MEMORANDUM

REVIEW TYPE: Preliminary Plan of Subdivision (Resubdivision)

PROJECT NAME: Chevy Chase View

CASE #: 120070520

Figure 1: Vicinity & Zoning Map

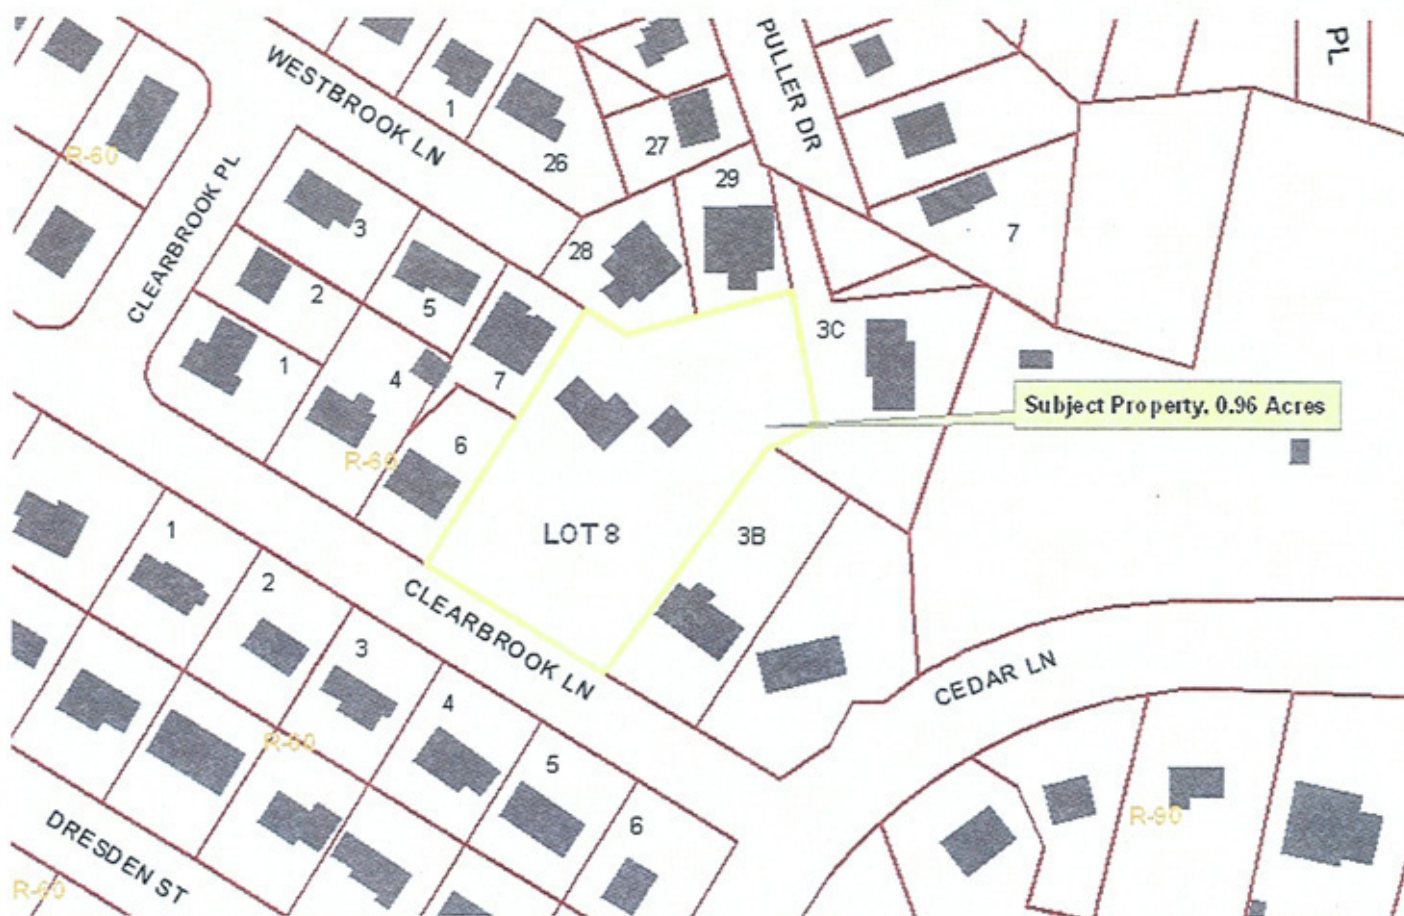
The site of this preliminary plan application, "Property" or "Subject Property", is located in the Kensington-Wheaton Master Plan area on Clearbrook Lane, 125 feet west of Cedar Lane. The site, pictured below in Figure 1, consists of a lot recorded by plat in 1993 that contains 0.96 acres zoned R-60. The Subject Property is surrounded by R-60 recorded lots. A one-family detached residential dwelling unit and separate garage structure are currently located on the Property. These structures are accessed from Clearbrook Lane via a private driveway. The topography of the site gently slopes to a low point at the rear of the site. There are seven large trees located on the Subject Property (24" DBH or greater) but no other significant environmental features:
